DATE 4-19-99		NO. 3434	
TITLE INSULATED TWIN CLIPS			
SUP. NO. 3434 J		DATED 10-24-98	
DWG. S	CK.	CHANGE K	
ENG. W	MR. JTB	N99068	
Sales JVB			
Busmann Division Cooper Industries St. Louis, MO 63178			
DISTRIBUTION			56 J

TITLE
INSULATED TWIN CLIPS

NO.
3434

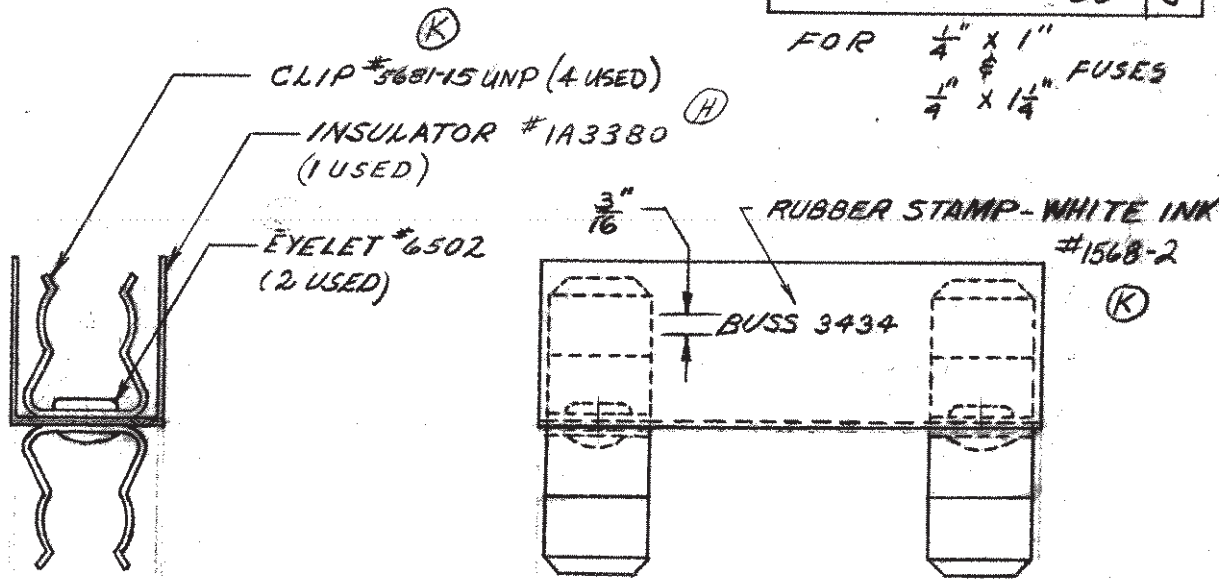
REV.	CHANGE DESCRIPTION	DATE	ECN #
I	REMOVED LABEL #6046 * ADDED PKG. SPEC. #IP1039	3-31-94	SN40025
J	SPECIFIED PACK. SPEC. #IP1039 AS "REGULAR" ADDED BULK PACKAGING SPEC. #IP1041	10-24-98	N98249
K	FUSECLIP #5681-15 UNP WAS #5681-15 * ADDED WHITE INK PART NO. #1568-2 REMOVED GOLDSBORO FROM DIST. * ADDED JUAREZ	4-19-99	N99068
